An Bord Pleanála
64 Marlborough Street
Dublin 1
D01 V902

Our Ref: SEV001SSFI
Your Ref: ABP-321238-24

Re: Planning application for a 110 kilovolt electricity substation, approximately 7.5 kilometres of underground electricity line and all associated works at Moyvannan, Feamore, Lisbaun, Carrownolan, Carrowncloghan, Carrowkeeney, Ardmullan, Curraghboy, Gortnasythe, Derryglad, Eskerbaun, and Brideswell, County Roscommon.

PLANNING-STAGE TRAFFIC MANAGEMENT PLAN

DRAWING NUMBER: 24154 - MWP -GR-XX-DR-C- 5107	REV: P01
--	-------------

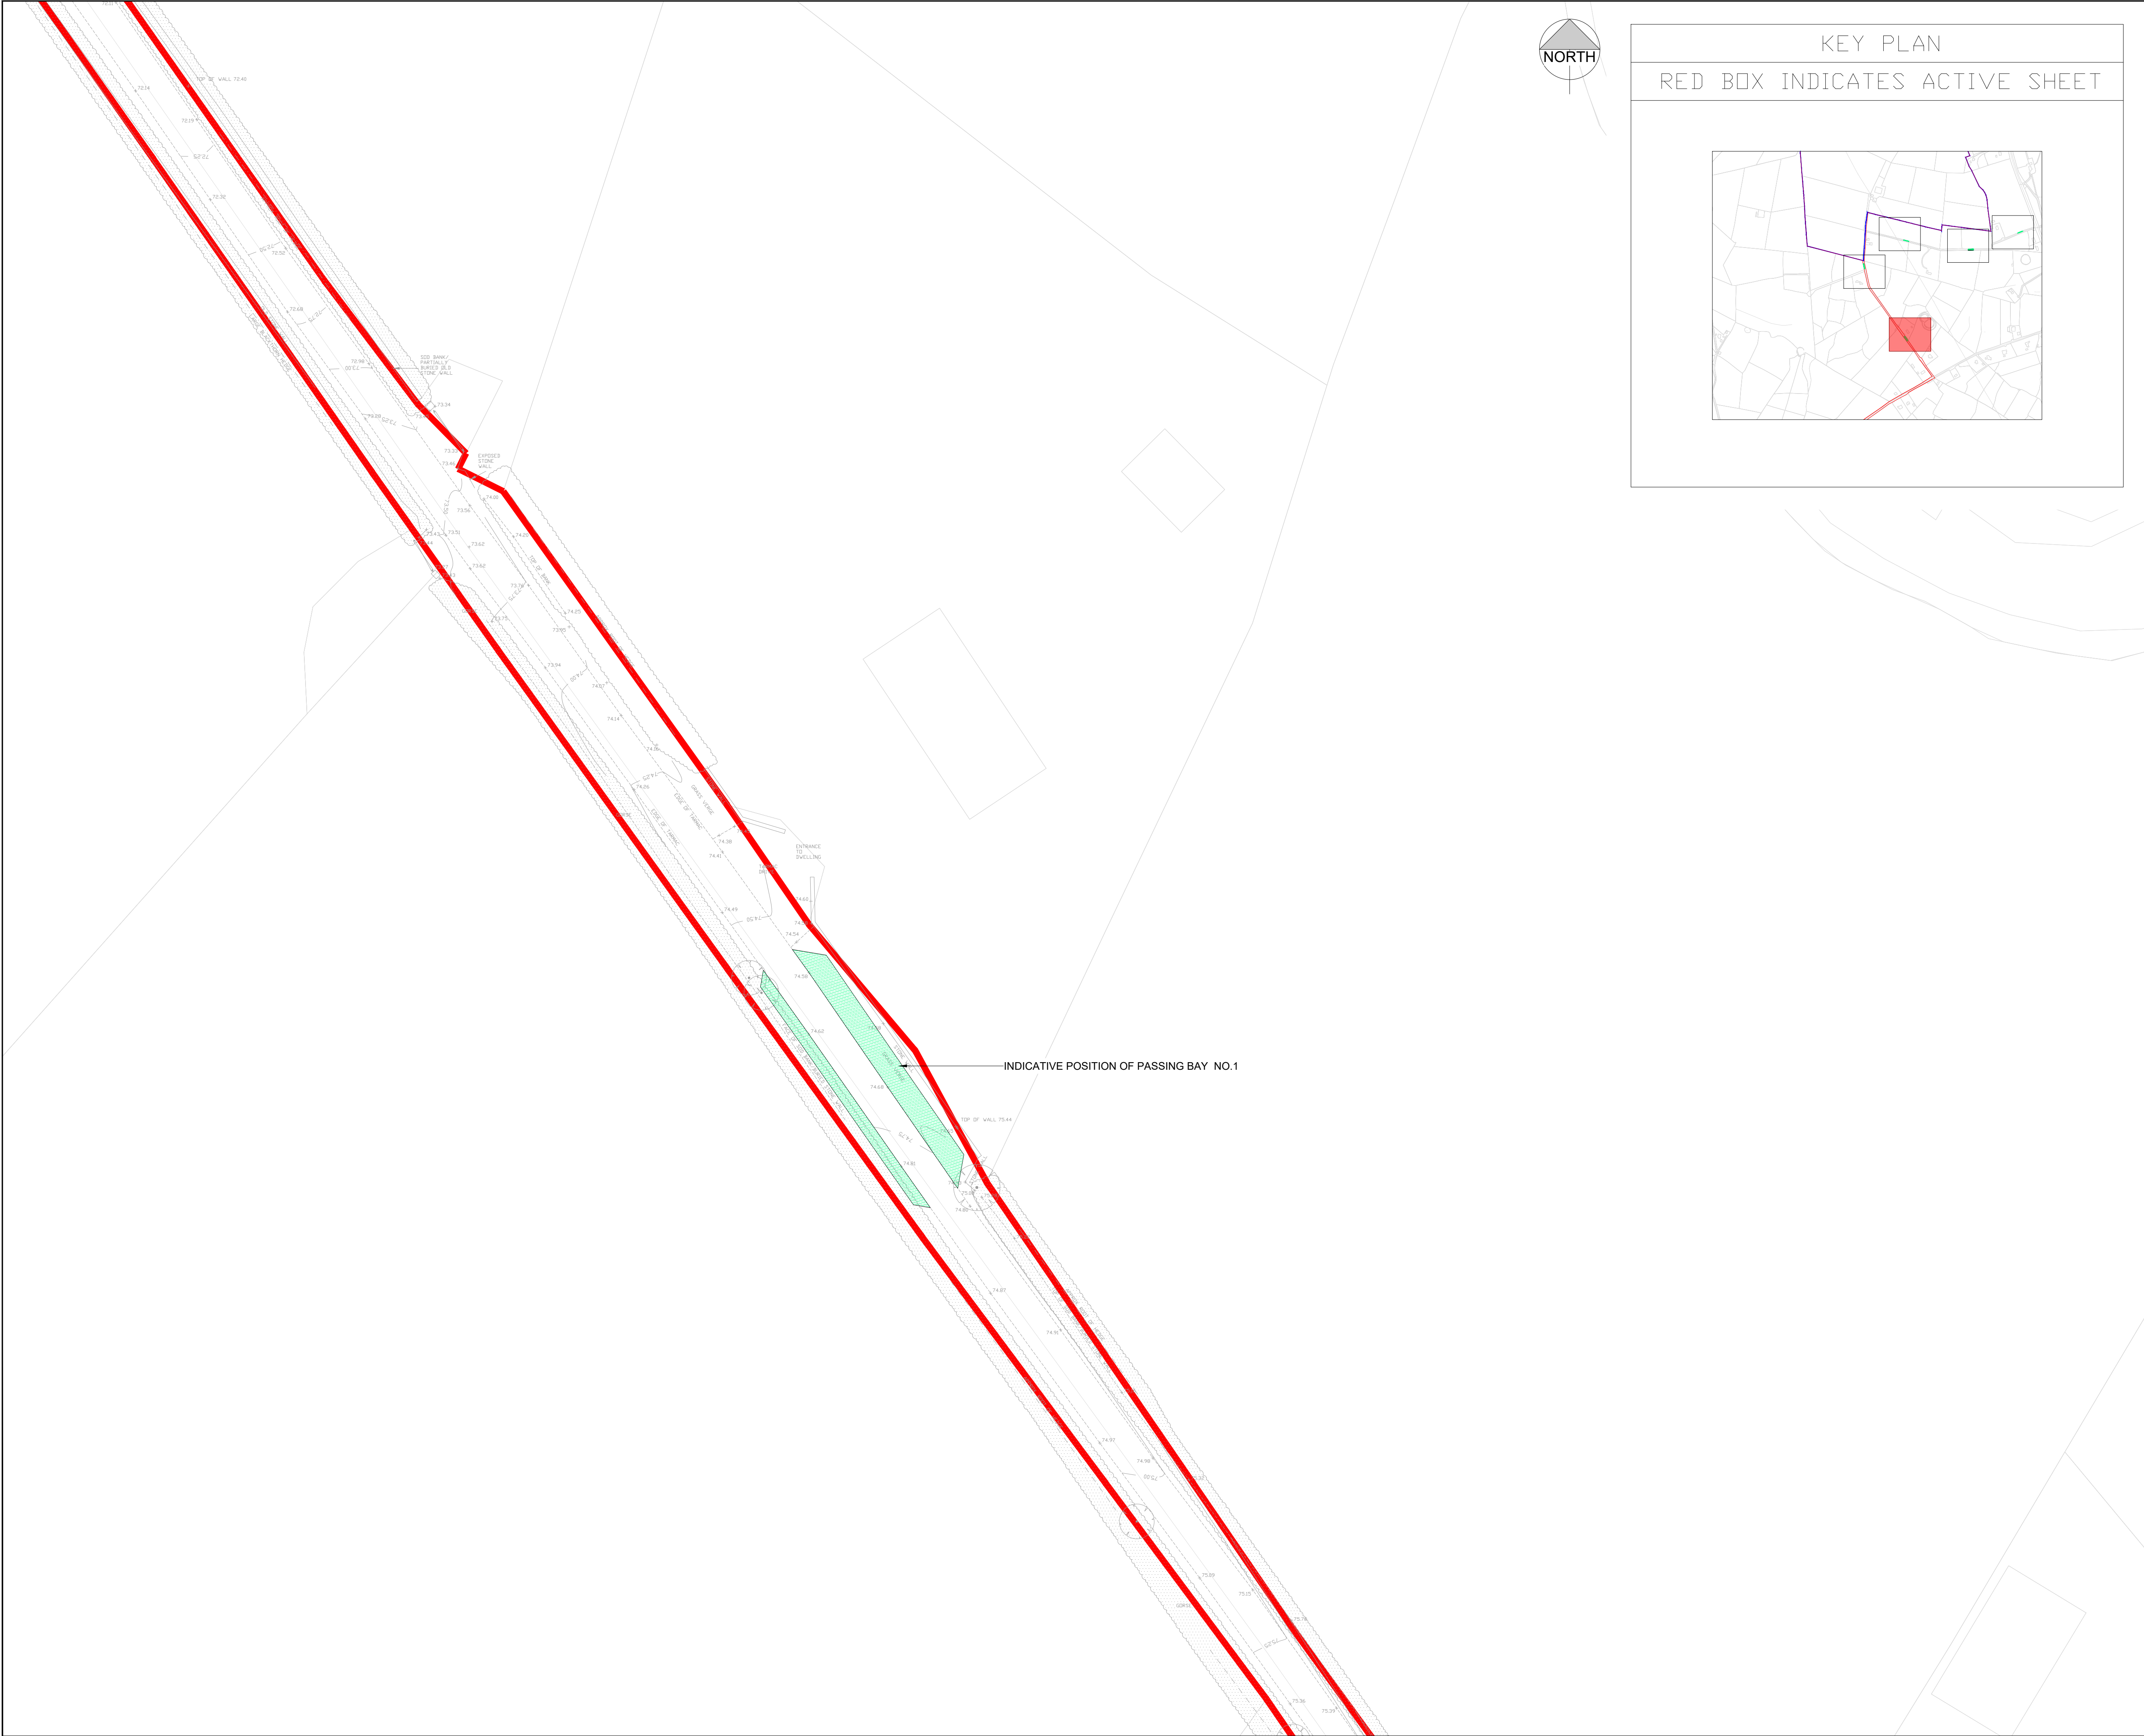
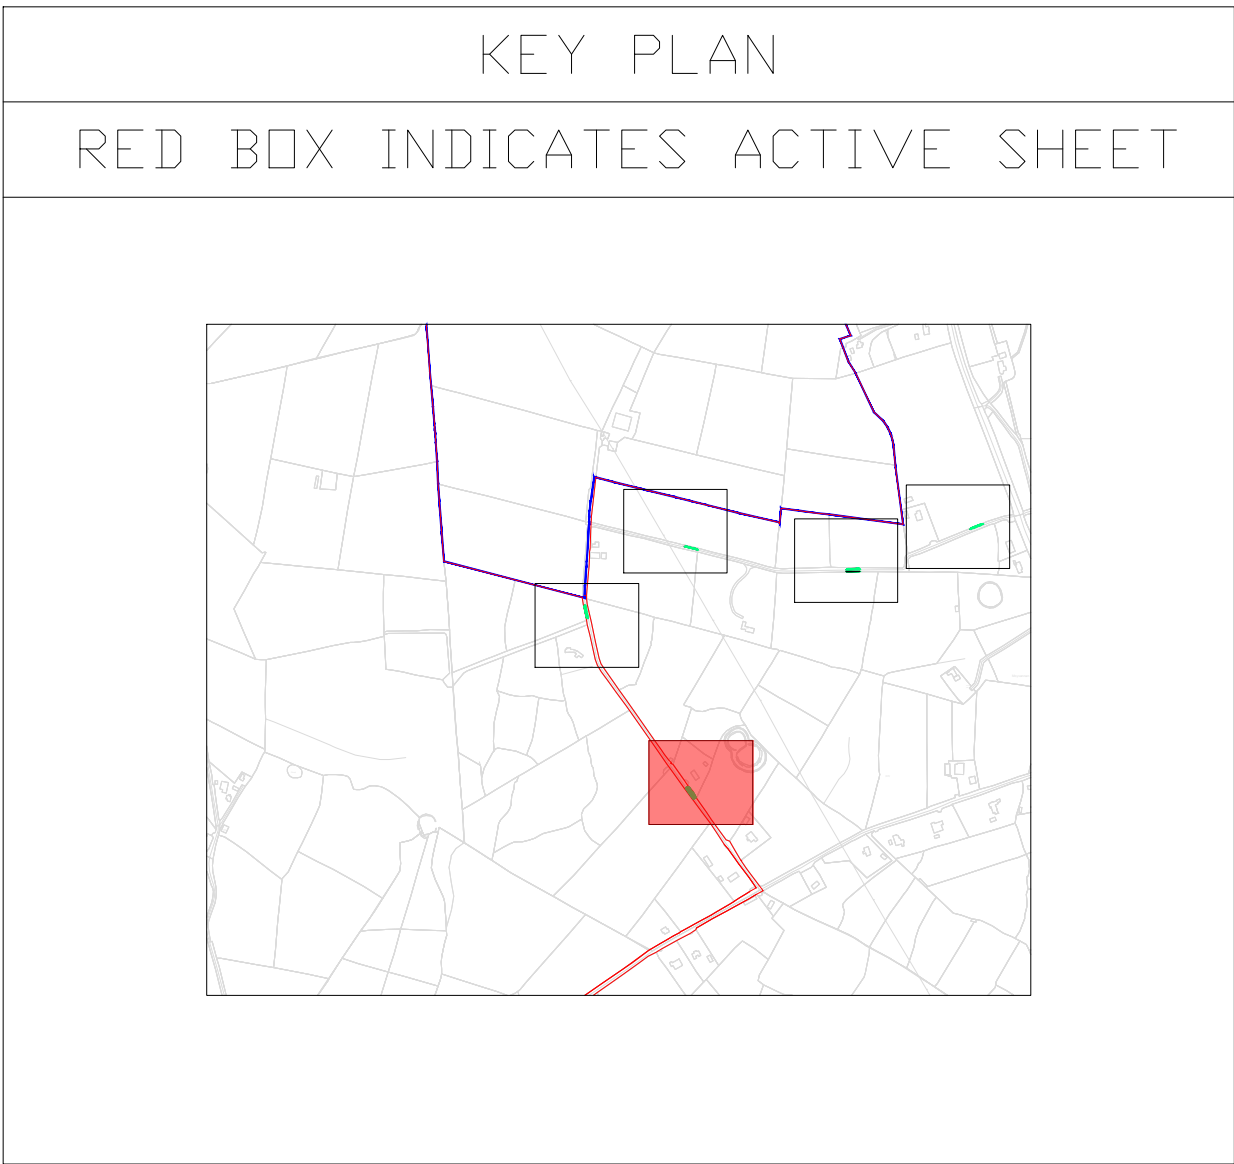
The Planning-Stage TMP provides for the installation of 5 no. passing bays along the L7551; the precise location and design of which will be agreed with the Planning Authority prior to the commencement of development. The passing bays will comprise a layer of aggregates placed within the roadside verge to enable HGVs and members of the public to safely pass each other and minimising the requirement for vehicles to reverse along the public road. On completion of construction activities, the passing bays shall be removed and the affected areas reinstated to their current condition. The provision of these passing bays will ensure that construction and public traffic can be accommodated along the L7551 and that sufficient passing opportunities are provided. It should be noted that construction traffic and material deliveries will be carefully managed to avoid, insofar as possible and minimise to the greatest possible degree, vehicles meeting along the L7551.

However, as described above and to be agreed with the Planning Authority, it is likely that a one-way system will be implemented along the L7551 for all traffic for the duration of the construction of the electricity substation; with traffic approaching the electricity substation site along the L7551 from the south and, previously, the L7556 and N61. On egressing the electricity substation site, construction traffic will travel in an easterly direction along the L7551 to the N61. With the implementation of this system for construction and public traffic, there will be no requirement for construction and public traffic to pass each other along the L7551; however, the 5 no. passing bays will be installed regardless as a further traffic management measure.
